**Re: Draft 2001 Annual and Monitoring Event 20 Reports for Site 9, Naval Air Station
Brunswick, Maine**

Attachment 1
US EPA New England Comments to Draft 2001 Annual Monitoring Report,
Site 9, Naval Air Station Brunswick, Maine

Attachment 2
US EPA New England Comments to
Draft Monitoring Event 20 Report (April 2002), Site 9
Naval Air Station Brunswick, Maine

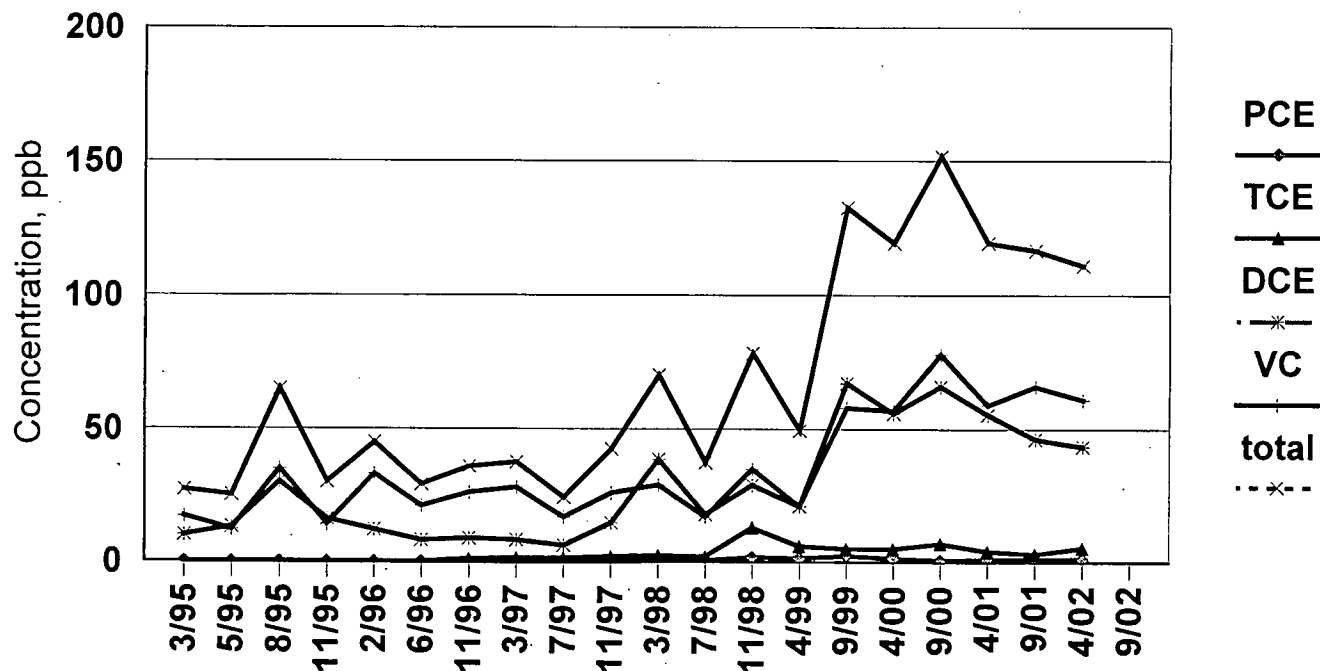
1. (NR) Section 2.2.2.1, Page 8, Paragraphs 1&@. Concur, please see comment ## below.
2. (NR) Section 2.2.2.1, Page 8, Paragraph 3. Same as comment #1 to 2001 Annual Report regarding the source of the 1,2-DCE.
3. (NR) Section 2.2.2.1, Page 8, Paragraph 4. If the VOC concentration spikes noted are "smoothed out" on a graph of total VOCs added for all wells, the below overall trend is discernable to EPA. A graph of the below is attached to hard copies of this letter; note that to be consistent, only low flow results have been graphed
 - a. 1995-1999: level to gentle rise with increasing rise in 1998-1999.
 - b. 1999-2000: steep rise
 - c. 2000-2001: leveling off
 - d. 2001-to date: gentle decrease (note that 4/02 event results have been included)

The VOC concentration "spikes" could be caused by many factors including actions at the NEX as noted. It's interesting to note that if either the two annual events are averaged or if either semi annual event were eliminated the same overall trend would be indicated to EPA.

5. (NR) Section 2.2.2.1, Page 8, Paragraph 6 regarding diffusion samplers, same as comment 8.b.
6. (ED/RR) Section 2.2.2.1, Page 9, MW-69 bullet. There appears to be a calculation error in Table A-1 which indicates a false rise in total VOCs by counting cis-1,2-DCE twice; as cis-1,2-DCE and within total 1,2-DCE. The trend graphs indicate this as well by showing both vinyl chloride and total 1,2-DCE (the vast majority of which is cis) decreasing, but total VOC's rising.
